## ORIGINATION FORM

Proposed Revisions to a Standard Plans Index  
(Please provide all information — Incomplete forms will be returned)

Date: May 12, 2021  
Originator: Brad Bradley  
Phone: (850) 414-4295  
Email: Brad.Bradley@dot.state.fl.us

Index Number: 522-002  
Sheet Number (s): 1 and 4 of 7  
Index Title: Detectable Warnings and Sidewalk Curb Ramps

LAST REVISION 11/01/20	REVISION	DESCRIPTION:	 FY 2021-22 STANDARD PLANS	DETECTABLE WARNINGS AND SIDEWALK CURB RAMPS	INDEX 522-002	SHEET 1 of 7
---------------------------	----------	--------------	--	---	------------------	-----------------

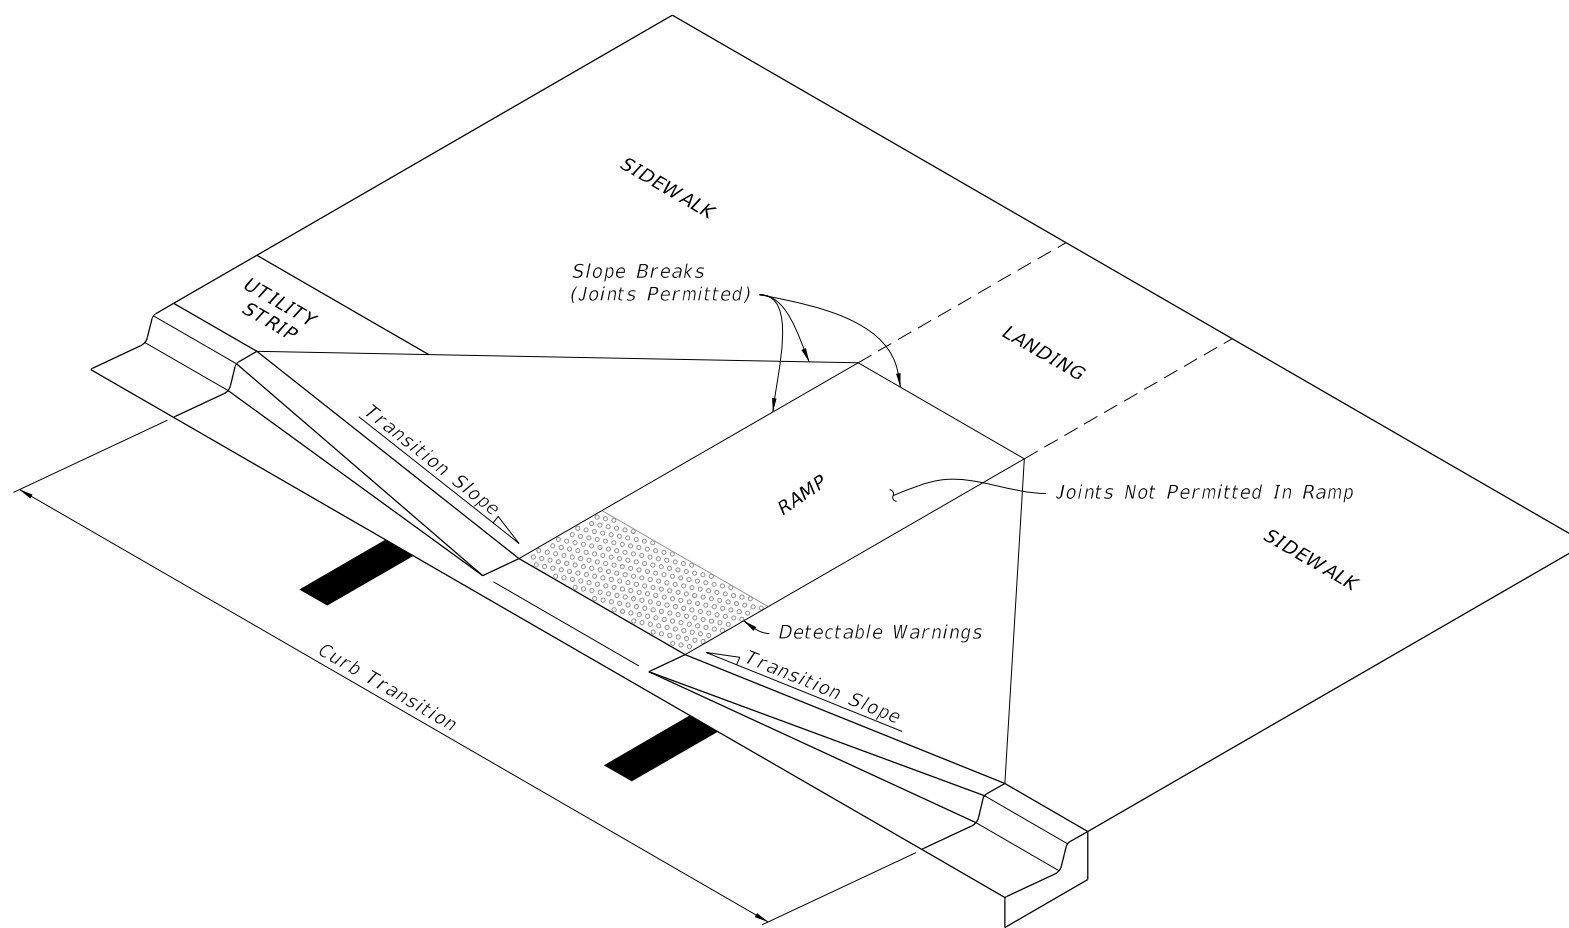
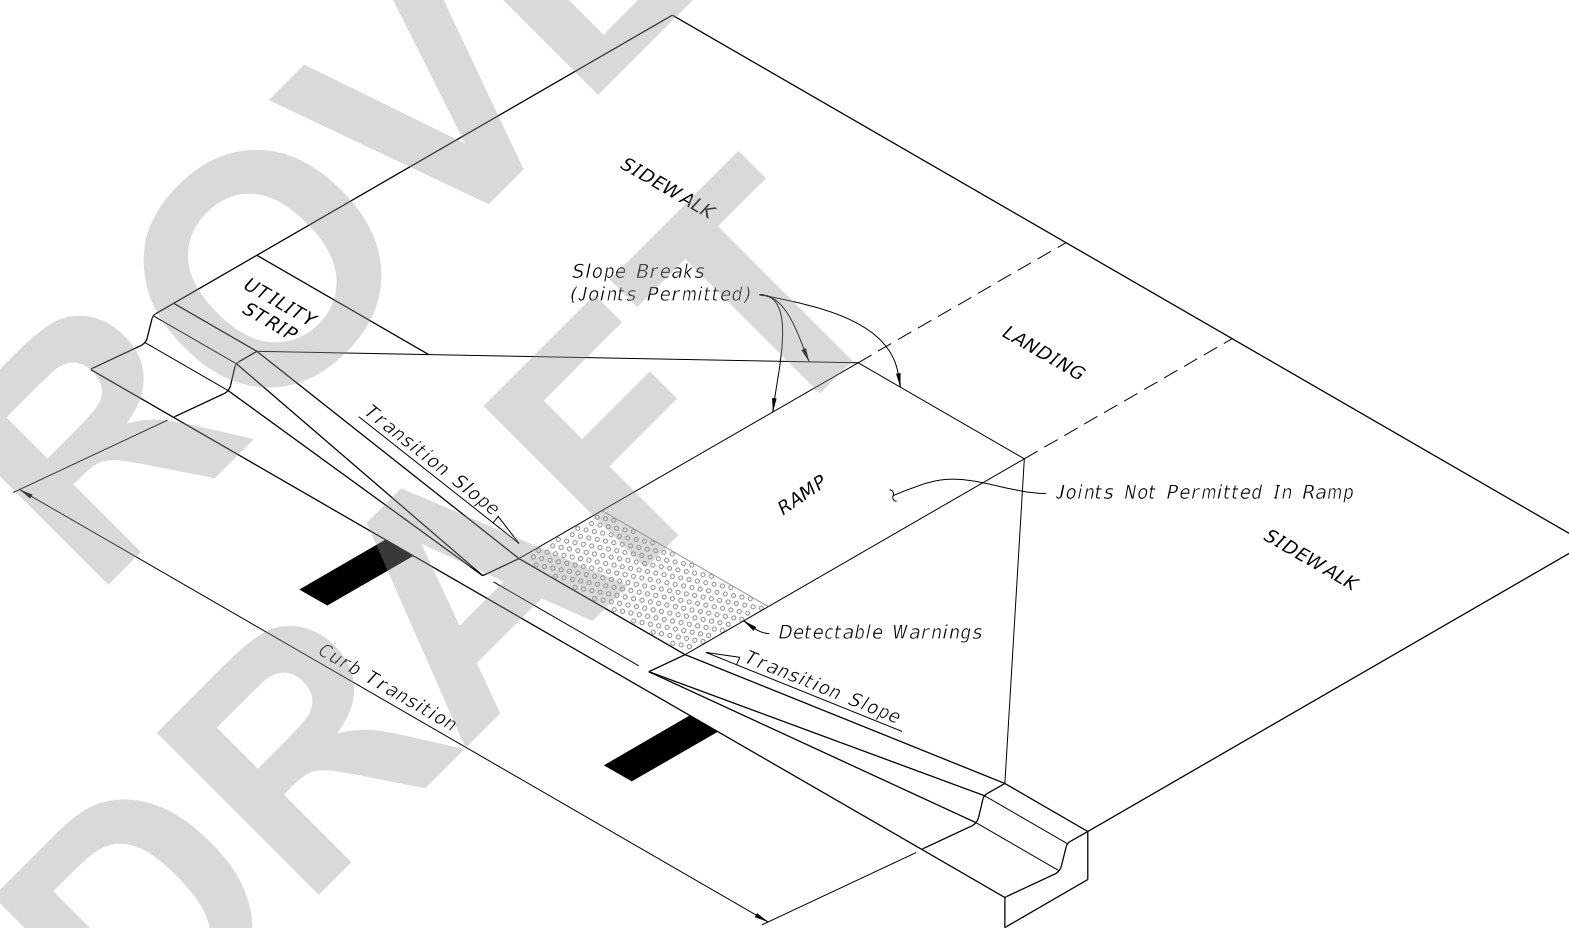
Sheet 1: Added Note 2.C.

**ADDED NOTE 2.C:**  
Width of Curb Ramp is 4'-0" minimum. Match sidewalk or Shared Use Path width as shown in the Plans.

- A. Refer to Index 522-001 for concrete thickness and sidewalk details.
- B. Remove any existing curb, curb and gutter, or sidewalk to the nearest joint beyond the curb transition or to the extent that no remaining section is less than 5 feet long.
- C. Width of Curb Ramp is 4'-0" minimum. Match sidewalk or Shared Use Path width as shown in the Plans.

CR-D

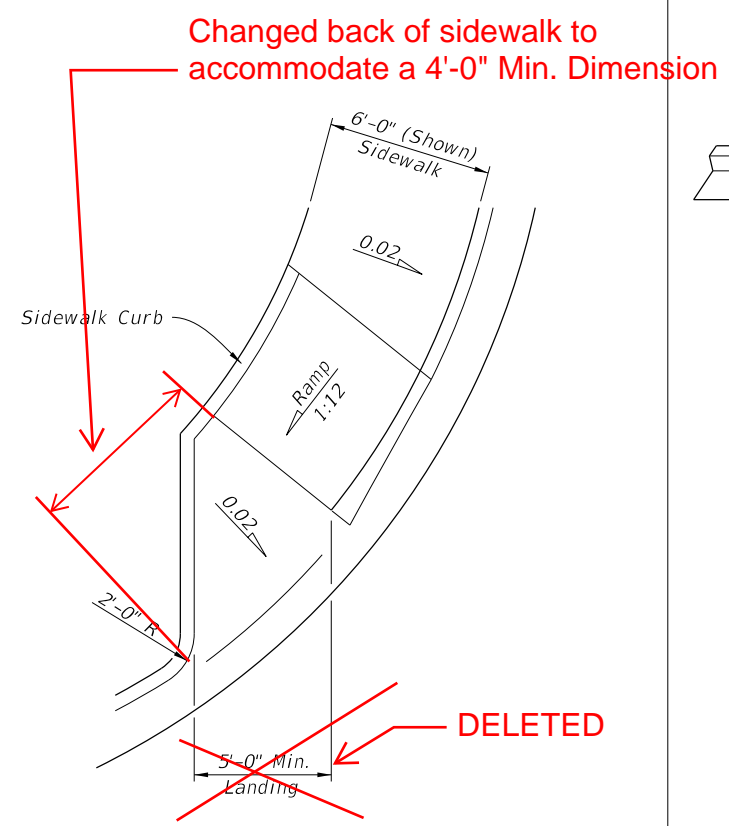
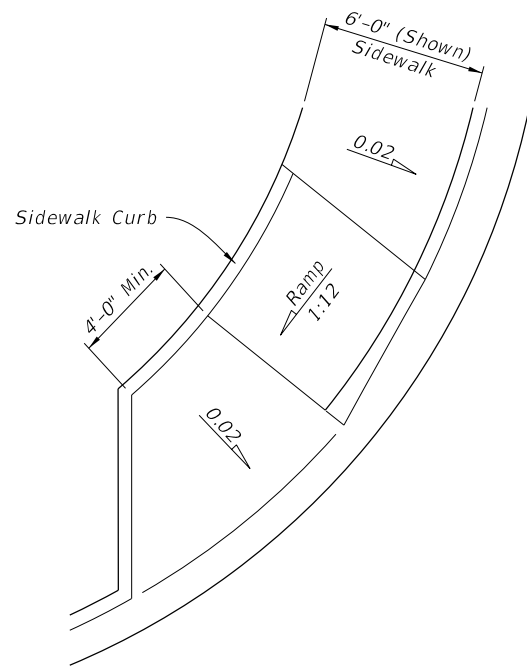
Sheet 4: Changed back of sidewalk in CR-D detail to accommodate 4'-0" minimum dimension.

CR-D is essentially half of a CR-C. The CR-C ramp currently shows the 4'-0" minimum dimension at the back of sidewalk to provide a large-enough level landing footprint for wheelchair maneuverability. The CR-D, as currently depicted in the Standard Plans, does not provide an optimal configuration for users of mobility devices. See next page for additional information.

For CR-D, provide 5'-0" standard (4'-0" minimum) dimension at back of sidewalk for the level landing at the bottom of the curb ramp (see figure). This provides the necessary plan area footprint for the level landing to allow for wheelchair maneuverability and change of direction. Otherwise, the footrest of a wheel chair would contact the curb face while the rear wheels are still on the ramp's sloped surface -- potentially resulting in an unstable/tip-over condition.

Ideally, the resulting curb return would remain parallel to and in alignment with the direction of the crossing, and that is why 5' standard is proposed with a 4' minimum.

Changed back of sidewalk to accommodate a 4'-0" Min. Dimension
